# Airworthiness Directive Schedule

### Piper PA-32 Series (Cherokee 6, Saratoga, Lance and Seaplane)

27 July 2017

**Figure 1**

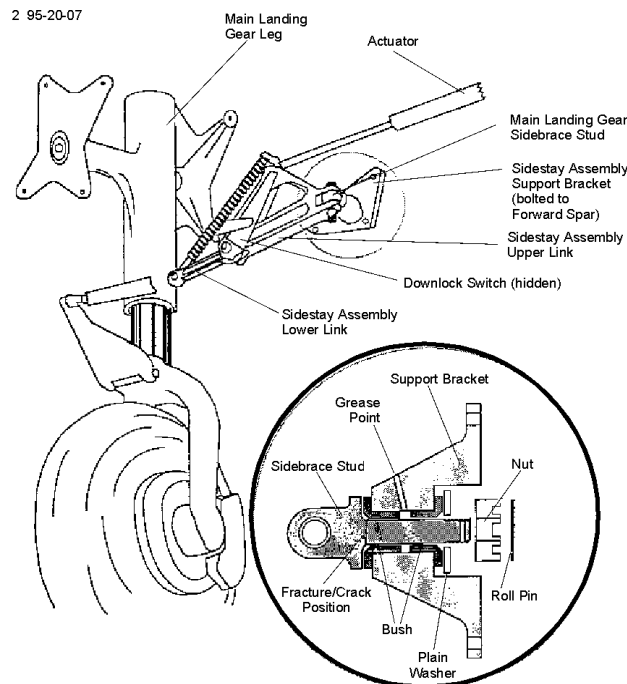
**Requirement:** To prevent main landing gear (MLG) collapse due to possible main gear sidebrace stud cracks which if not detected and corrected could result in loss of aircraft control during landing, accomplish the following:

Remove both the left and right main gear sidebrace studs from the aircraft per the instructions in the landing gear section of the aircraft MM. Inspect both the main gear sidebrace stud for cracks using Type I (fluorescent) liquid penetrant or magnetic particle inspection methods. Figure 1 of this AD depicts the area where the sidebrace stud is to be inspected.

For any main gear sidebrace stud not found cracked, before to further flight reinstall the stud per the instructions in the Landing Gear section of the applicable MM, and reinspect and replace (as necessary) per this AD.

For any main gear sidebrace stud found cracked, before to further flight replace the cracked stud with a serviceable part per the instructions in the Landing Gear section of the applicable MM and accomplish one of the following, as applicable:

- Reinspect and replace (as necessary) per the repetitive requirements in this AD, or
- For affected PA32R-300 aircraft the 9/16 inch main gear sidebrace studs (P/N 95299-00, 95299-02 or 67543 as applicable) are no longer manufactured: Install a new main gear sidebrace stud bracket assembly P/N 95643-06, 95643-07, 95643-08 or 95643-09 as applicable. No repetitive inspections will be required by this AD for when this bracket assembly is installed on both the LH and RH sides, or

- Ream the existing two-piece bushings P/N 67026-6 to an inside diameter of .624 inch to .625 inch, chamfer the head side of the bushing to accommodate the radius in the shank of the main gear sidebrace stud and install the 5/8 inch stud P/N 78717-02. No repetitive inspections will be required by this AD when this action is accomplished on both the LH and RH bracket assemblies. If the bushings cannot be reamed while installed in the bracket (i.e., the bushings are loose), then install a main gear sidebrace bracket assembly P/N 95643-06, 95643-07, 95643-08 or 95643-09, as applicable.
